**Car Stereo
Service Bulletin**

Model: XEC-1000

No.179

Subject: No Audio Or Buzzing/Engine Whine

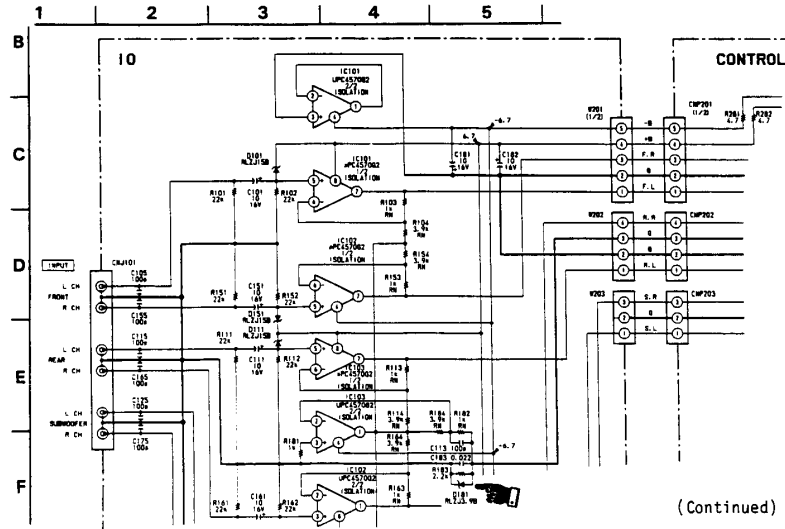
If the unit is brought in with a complaint of no audio output or buzzing in the output, perform the following procedure listed below. This symptom will usually occur in systems which have a number of high powered amplifiers.

Solution: Remove D181 from the "IO" Board and inspect the Main Board for any open traces in the locations shown.
